Access Compliance Report

Public Rights-of-Way

Intersection ID: 26278	Main Street: BEVINGTON_PL	Cross Street: WESTBURY_WOODS_DR	Location: SW
ADA ID: 392B7A013EA2	Ramp Type: PerpDiag	Initial Pass/Fail: Fail	Overall Compliance: No
Severity Score: 22.5			
Codes/Mitigation Info/Possible Solution		Field Measurements/Component Compliance

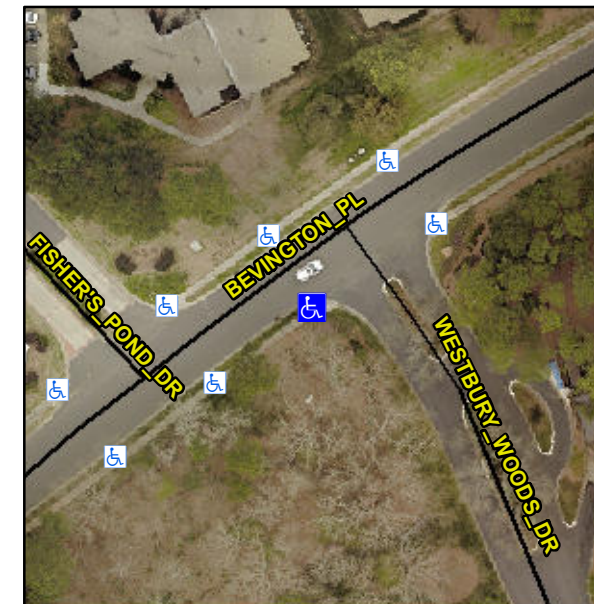
R304.5.1, R304.2.2, R304.5.3

Compliance	Description	Data	Compliance	Description	Data
N/A	Ramp Length (in)	61.0	No	Ramp Slope (%)	11.2
No	Ramp Width (in)	47.0	No	Ramp XSlope (%)	3.7
N/A	Flare Type LT	N/A	N/A	Flare Type RT	N/A
N/A	Flare Slope LT (%)	N/A	N/A	Flare Slope RT (%)	N/A
N/A	Flare Traversable LT?	N/A	N/A	Flare Traversable RT?	N/A
N/A	Landing Length (in)	N/A	N/A	DWS Provided?	N/A
N/A	Landing Width (in)	N/A	N/A	DWS Contrast?	N/A
N/A	Landing Slope (%)	N/A	N/A	DWS Length (in)	N/A
N/A	Landing X Slope (%)	N/A	N/A	DWS Full Width?	N/A
N/A	Landing Curb? (Y/N)	N/A	N/A	DWS Offset (in)	N/A
N/A	Shared Landing?	N/A			
N/A	Gutter Ponding?	N/A	N/A	Gutter Slope (%)	N/A
N/A	Gutter Lip Ht (in)	N/A	N/A	Gutter X Slope (%)	N/A
N/A	Painted X Walk1?	No	N/A	Painted X Walk2?	No
	X Walk 1 Direction	To NE		X Walk 2 Direction	To NW
N/A	X Walk 1 Width (in)	N/A	N/A	X Walk 2 Width (in)	N/A
	X Walk 1 Slope (%)	2.0		X Walk 2 Slope (%)	1.4
	X Walk 1 X Slope (%)	3.1		X Walk 2 X Slope (%)	2.6

N/A	Ramp inside XWalk1?	N/A	N/A	Ramp inside XWalk2?	N/A
	Road Slope (%)	3.9	N/A	Clear Space?	N/A
	Road X Slope (%)	0.7	N/A	Clear Space to XWalk (in)	N/A
N/A	Any Obstructions?	N/A	N/A	Storm Grate/Utility Hazard?	N/A
	Obstruction Type			Storm Grate/Utility Type	
		N/A			N/A
			Yes	Surface Condition? (G/P)	Good

Remove & Replace Curb Ramp With Two New Directional Ramps or Equivalent.
